Re: Planning Application: DC/23/67858

No [redacted], Lochranza Croft, Great Barr, Birmingham, B43 7AA.

Proposed single and two storey side and rear extension, and single storey front extension.

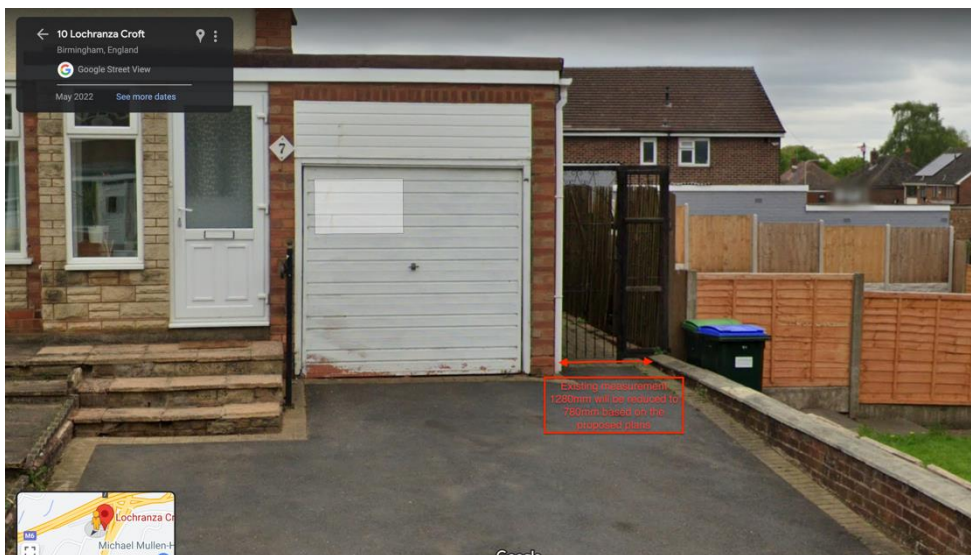
- The revised proposal does not increase the width of the footpath at the side of the property, which is the only access to the rear. While the dimension measurement has been removed from the amended drawings, it is still 0.885m wide in contravention of the Sandwell Residential Design Guide that requires 1.00m width.

- The Design Guide states 'All dwellings must have safe and convenient rear access to enable the maintenance of rear garden areas and provide access to external storage including bin storage. Routes must be provided that are wide enough and sufficiently direct and safe for residents to use them.'

- The current proposal only has an 885mm wide footpath at the side of the property which would limit access to service and carry out ongoing maintenance of the rear of the building. Along with causing difficulties for wheelchair users, limiting who can occupy the property in the future. This is reduced further at the front of the garage due to the retaining wall on the driveway, leaving only 780mm to access and service the rear (photo below).

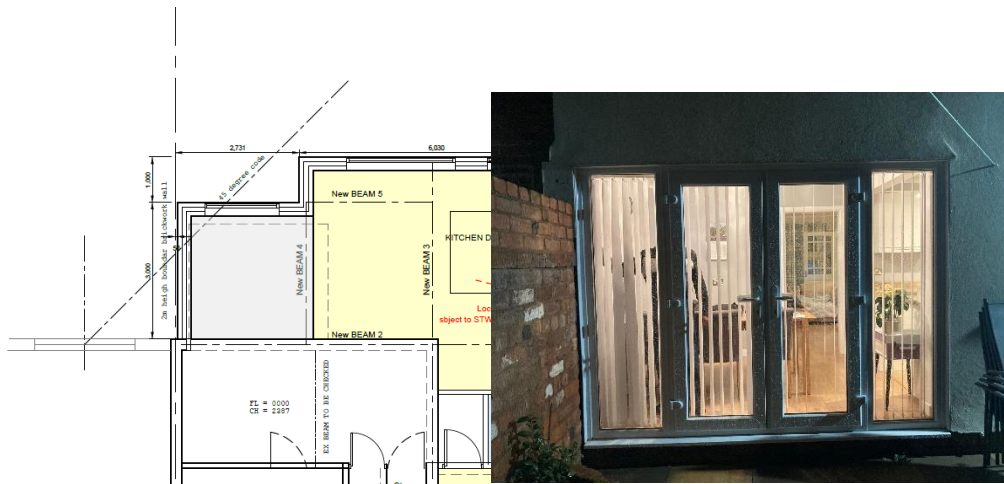
- The proposed three-metre single storey rear extension directly adjacent to No. [redacted] is shown in grey on the submitted drawings and is not highlighted in yellow (new floor area or alterations) to indicate any alterations are to be made to this area of the property. It is also referred to in the committee report as an existing extension. This is misleading as the existing rear single storey extension, a UPVC conservatory, will be demolished and replaced

by a single and two storey extension which will be wider, longer, and taller than the existing conservatory.
